FERN AVE., LONG ISLAND

Subject: Stop order on work under permit 46/710 to  
cover construction of a building at Fern Avenue,  
Long Island (Assessors Lot No. 100-D-1)

Subject: Building permit for construction of one-story frame cottage on Fern Avenue, Long Island.  
(Assessors Lot No. 100-A-18)

To construct 1 story frame cottage 12'x20'.

Report No. 2  
New Jersey State Office of Water Resources  
Metuchen Branch Office of Land  
Inspected April 09, 1946.

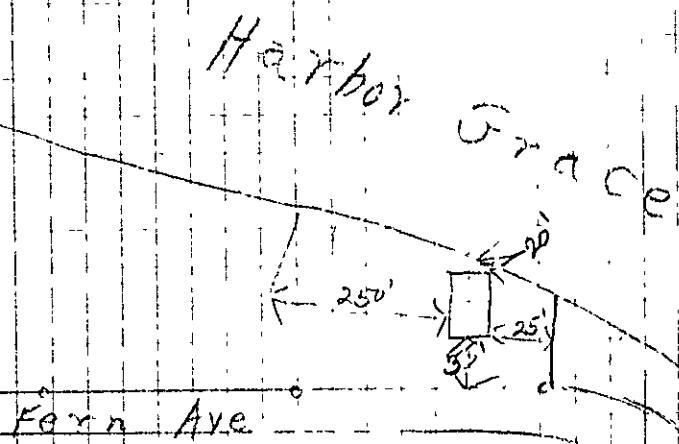
Several of the concrete piers, sills and walls  
have been laid down and some features in  
the work already done that do not  
according to either the plan or the  
specifications.

The 3 $\frac{1}{2}$  x 10' sill was stated since a 4"  
cheesecull will probably be 3 $\frac{1}{2}$  but sill  
will be about 3 $\frac{1}{2}$ " and be used again  
as a header joint permitted. Delicate  
finishing of all applications as 8 $\frac{1}{2}$ " soaker  
3 $\frac{1}{2}$ "

The sill appears less than a half grade in  
places with one end practically in  
the ground for a distance of 2' 3"
